ONS-2015-052

Subject: Response to Request for Additional Information dated March 27, 2015, Related to the Oconee Expedited Seismic Evaluation Process (ESEP) Report

**Oconee Nuclear Station Units 1, 2, and 3
Duke Energy Response to Questions from NRC E-mail dated
March 27, 2015, Related to the Oconee
Expedited Seismic Evaluation Process (ESEP) Report**

The East-West SSE floor response spectrum is
Figure A-102 of OSS-027B.00-00-0002, shown below:

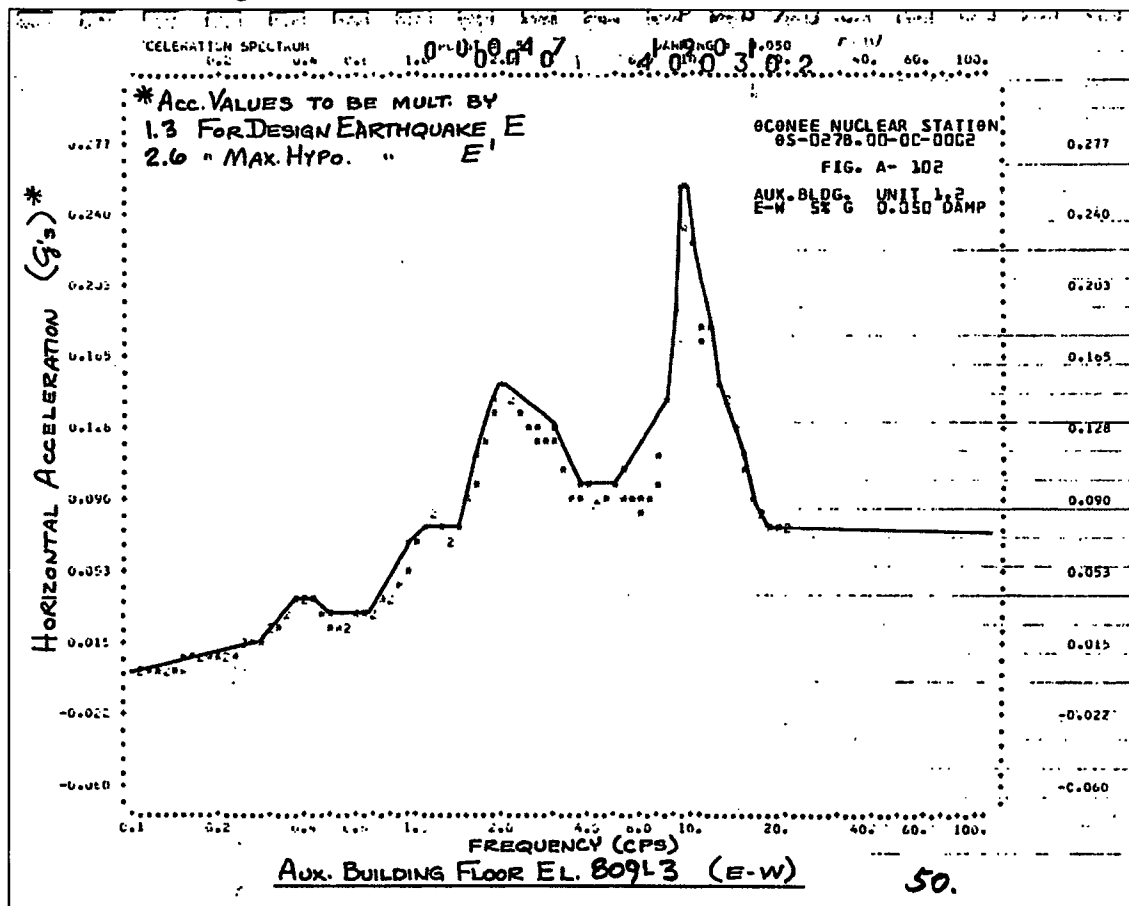
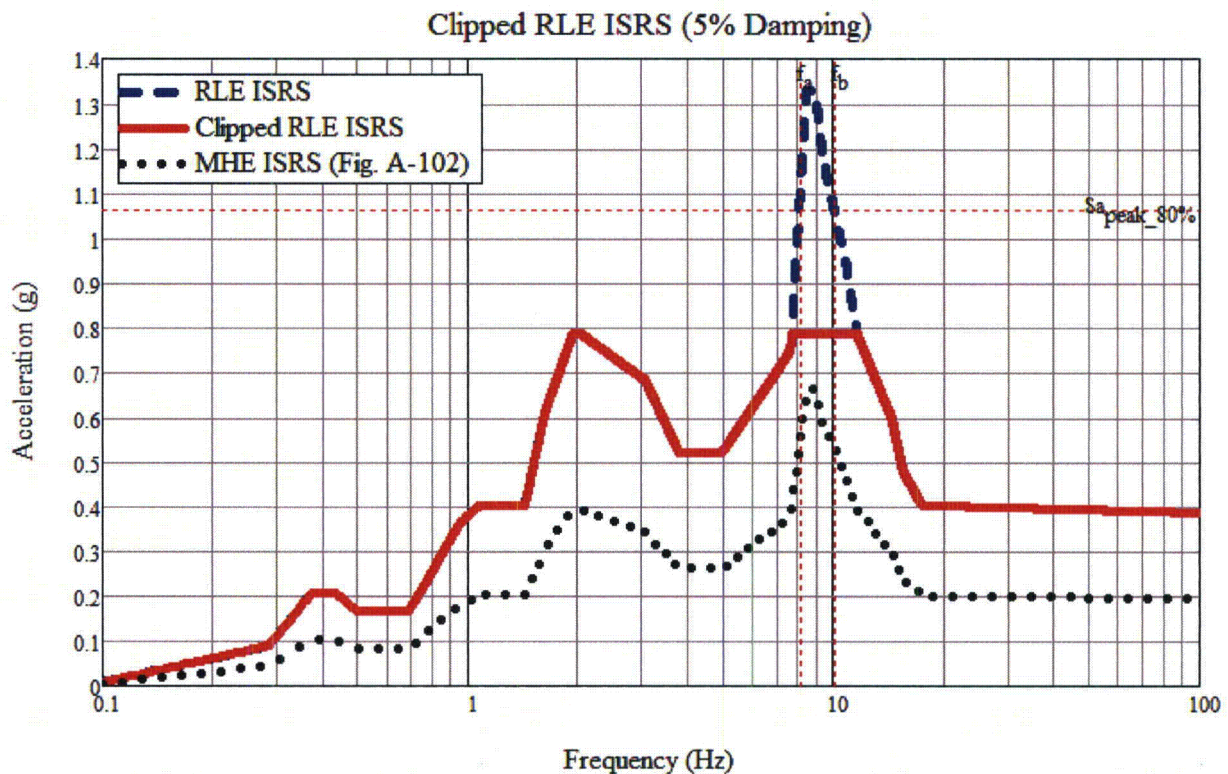
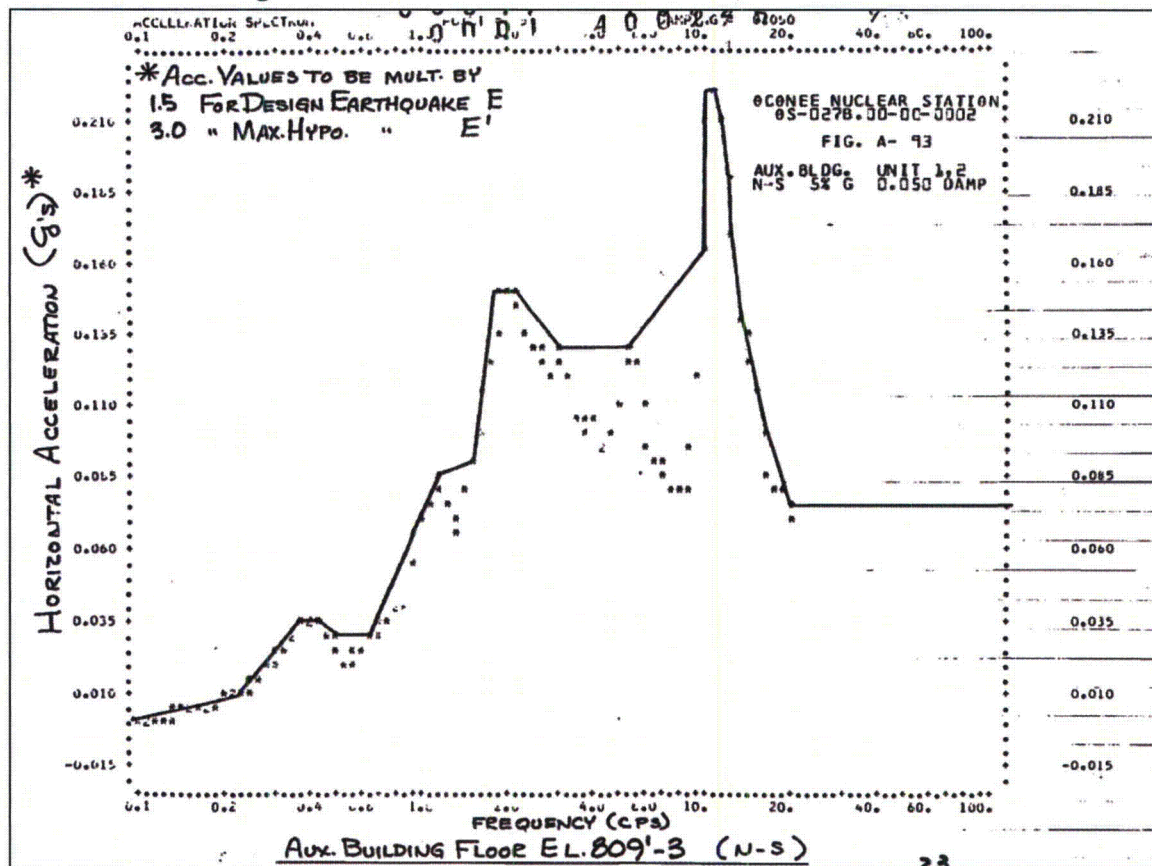
ESEP Report Section 5.2 states, “[in-structure response spectra] ISRS for ESEP evaluation of components located outside the SSF [Standby Shutdown Facility] were estimated by scaling the ONS [Oconee Nuclear Station] design-basis SSE [Safe Shutdown Earthquake] ISRS by the RLGM [Review Level Ground Motion] scale factor of 2.0.” However, ESEP Report Section 6.4, “Functional Capacity Screening Using [Electric Power Research Institute] EPRI NP-6041-SL,” states, “The SSE ISRS were amplified by a factor of 2.0 throughout the frequency range and were then clipped (per EPRI 1019200), using the methodology in EPRI NP-6041-SL, Appendix Q,...” It appears that raw ISRS with sharp peaks and valleys, but with peaks clipped, were used for screening. The staff expected that the “ONS design-basis SSE ISRS” used for screening would be typical broadened, enveloped ISRS used for seismic design of Category I SSCs.

Please clarify how raw ISRS and peak clipping were used in the screening process, and provide the technical basis. Additionally, provide the range of calculated clipping factors, the reference for the equation used, and an example showing representative raw ISRS and the corresponding clipped ISRS.

ONS design-basis ISRS are given in OSS-027B.00-00-0002, Revision 8, “Specification for the Seismic Displacements and Response Spectra for the Turbine, Auxiliary, Reactor and Standby Shutdown Facility Buildings.” An example spectrum, typical of each building other than the SSF, is given below. The spectrum is not a typical broadened ISRS, which is peak-broadened by +/-15%. The ISRS were considered to be raw, unbroadened spectra for the ESEP evaluation. The exception to this was ISRS in the SSF. The SSF ISRS were developed later than the original design-basis spectra. The SSF has both raw, unbroadened spectra and peak-broadened ISRS available. The ESEP evaluation used the raw, unbroadened spectra as per EPRI NP-6041-SL.

Peak clipping was performed only for use in screening against EPRI NP-6041-SL Table 2-4 or for comparison to test response spectra. Clipped-peak spectra were not used for anchorage evaluations. The technical basis for using clipped-peak spectra, for comparison to wide-band earthquake experience or test response spectra, is given in EPRI 1019200, Seismic Fragility Applications Guide Update. The ESEP peak clipping followed the methodology in Appendix Q of EPRI NP-6041-SL. The calculated clipping factors ranged between 0.55 and 1.0. If the calculated clipping factor would reduce the primary peak to less than an adjacent peak, the reduction was limited to the value of the second peak. None of the clipping factors were less than 0.55.

The following example shows the peak clipping for the ISRS for Elevation 809'-3" of the Unit 1-2 Auxiliary Building. The design-basis ISRS are from Figures A-102 and A-93 of OSS-027B.00-00-0002 for the East-West and North-South directions, respectively. The example also shows the averaging of the peak spectral accelerations, which is discussed in Question 2.

The RLGM spectral accelerations are 2.0 times the SSE (MHE), which are 2.6 times the spectral accelerations in the figure. Thus, the RLGM peak spectral acceleration is 5.2 times the peak spectral acceleration from the figure, or 1.33g. The clipping factor is computed using Equations O-2 and O-6 of EPRI NP-6041-SL. The calculations and resulting peak-clipped spectrum are shown below. Note that RLE refers to the RLGM.

Note that manual clipping was performed in order to prevent the clipped peak from falling below the secondary peak, which is relatively wide at 80% of the respective peak.

Figure 4-5. ONS SSE (5% Damping)(Corrected).

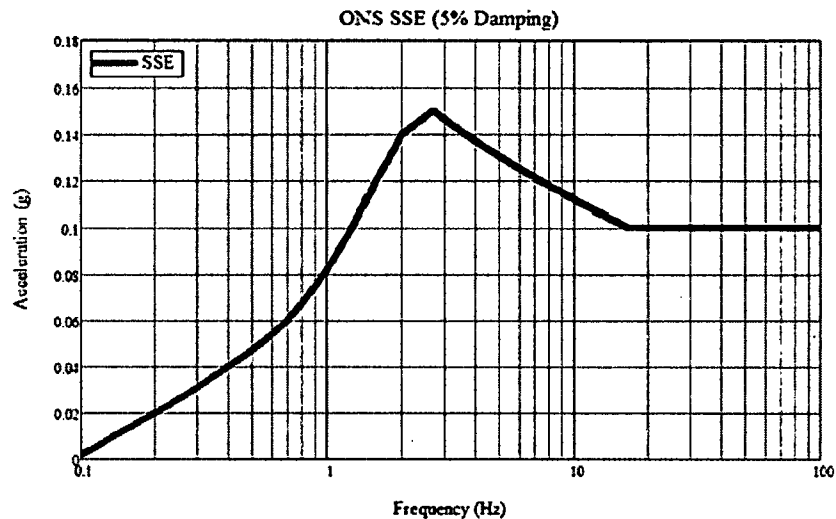
The graph in Figure 4-5 of the ESEP report is the incorrect illustration.
The figure below is the correct graph.

The purpose this graph had in the report was to illustrate a subset of data from another graph (also in the report). The figure in the original report had an incorrect graph line, which invalidated the illustration, but had no bearing on the technical validity of the report.

This graph is submitted to correct the docket.
